01 Heritage roofline/new developement

a. Heritage roof interface to new built form addition.

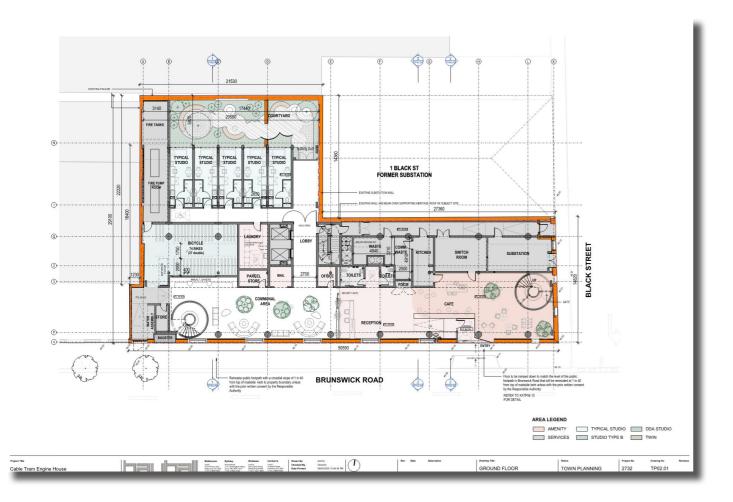
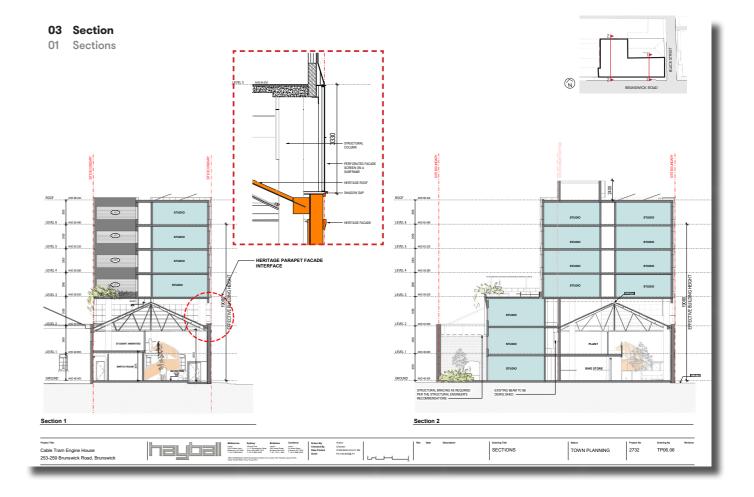
HV - Further sections to understand: the relationship between the heritage roofline and the new development, including columns and truss interfaces; through all frontages.

The Architectural Town Planning submission (Section 03 - Sections 1 and 2) reasonably describes the interfaces between the heritage roofline and the proposed new addition to the Cable Tram Engine House.

We confirm that Level 03 floor slab set at AHD 56.630 wholly sits over the existing roof plane.

The ridge line of the heritage roof sits at AHD 56.000. Accounting for a 200mm slab thickness there is a clear separation of 430mm from the heritage ridge line (AHD 56.000) to the underside of the proposed Level 03 slab. Transfer beams will be located under the level 03 slab to accommodate the proposed relocation of columns within the heritage space interior. We have confirmation from our structural engineer (TTW) that these beams will have reasonable clearance to the existing roof, particularly ridge line, to account for any deviation in the heritage roof form.

02 Heritage parapet/facade interface

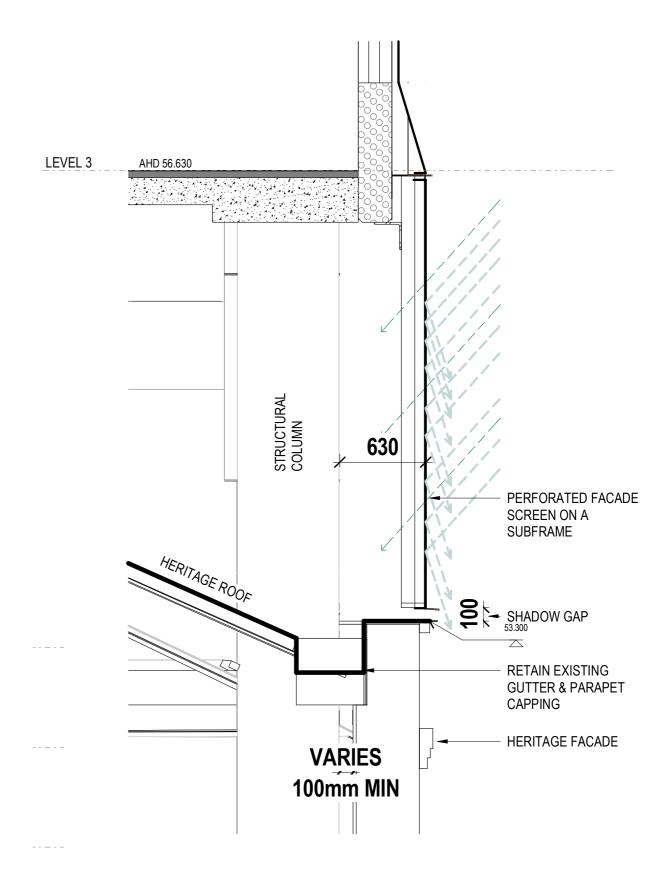
HV - With regard to the heritage parapet/facade interface. Please confirm if the shadow gap is sufficient to allow for level differences across the length of the parapet and the design detail of any apron flashing between the new built form and parapet, noting that it would be preferable to avoid an apron flashing.

With reference to the attached sections we confirm that a shadow gap of 100mm is proposed at the heritage parapet interface to allow for minor level variations. The gap is kept to a minimum as the survey currently indicated no variation in the heritage parapet height.

The intention is to both maintain a tight visual interface between the old and new built form and prevent viewing to the underside of the Level 03 slab.

We confirm that apron flashing is not necessary in this design. A projected flange extrusion effectively redirects water runoff away from the heritage parapet and façade, thereby removing the need for visible flashing. Due to the perforated nature of the interface screens—and given that the junction between the new structure and the heritage fabric is not intended to be waterproofed—additional flashing is not considered necessary.

03 Structural Design rationale

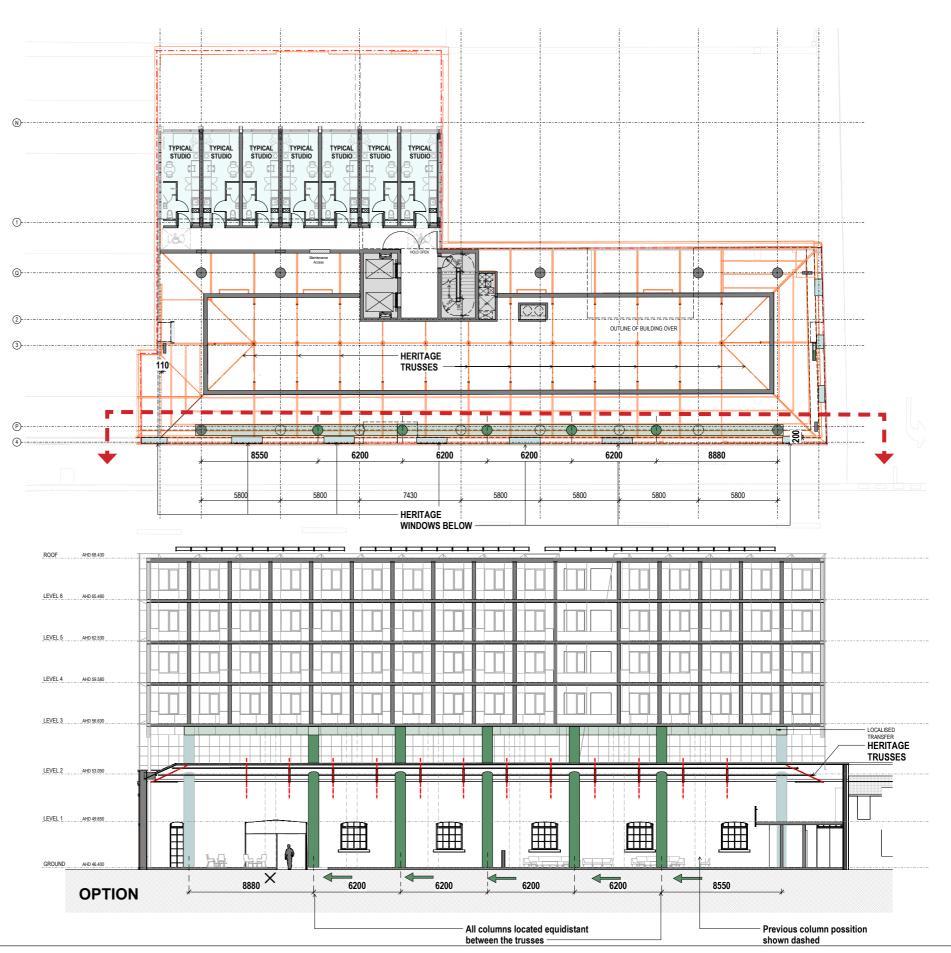
HV - Further consideration of the column placement. The column placement appears to be based on a regular grid placement, rather than the heritage building. The placement of columns directly in front of heritage windows and doors is not a good design outcome, and requires reconsideration. Please provide options to address this matter.

With reference to the attached drawings, the current proposed placement of new columns within the heritage space has been designed so that in most instances they sit equally between the existing heritage trusses to allow a visual balance between old and new within the interior.

Note that the existing windows do not align to the existing truss layout.

To satisfy both HV's stated requirements the attached solution is proposed:

A shallow transfer beam will be introduced under the level 03 slab to allow the new columns to be re-aligned with more flexibility, allowing them to sit exactly between the heritage trusses (in all instances) and not impede any of the existing windows. This initiative will reduce the number of columns along the south wall from 8 to 7.

The transfer beam will be screened by the perforated façade cladding.

04 Connection with the building past

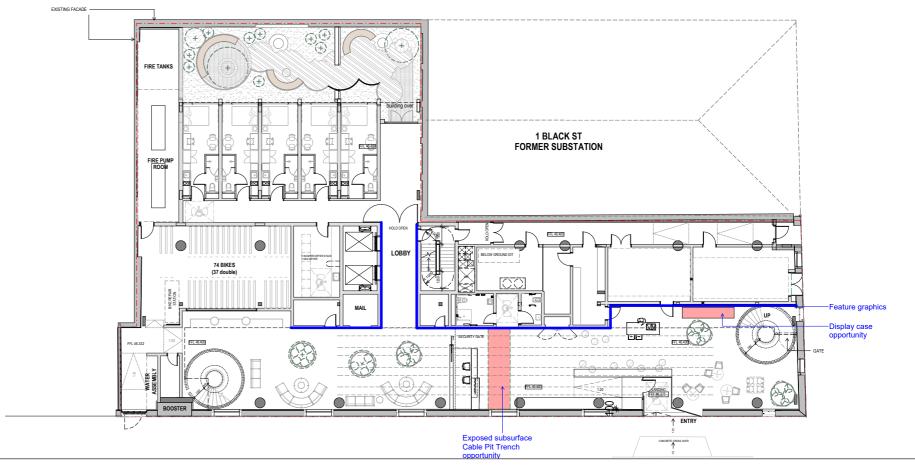
HV - Following the update of the Archaeology Heritage Impact Statement required below, address from a design perspective how a section of any remaining subsurface cable tram infrastructure could be revealed in an interpretation scheme for the interior.

The subsurface cable tram infrastructure can be expressed and revealed in any number of ways, and it has always been the design team's objective to do this with HV's guidance.

- 1. The subsurface cable trays can be exposed in the reception area under trafficable glass, with an explanatory plaque, so that a connection with the buildings past use can be stablished at entry.
- 2. The interior design will feature graphics of the cable house machinery sourced by our heritage consultants.
- 3. Found objects of significance, during excavation, can be mounted or displayed in cases.
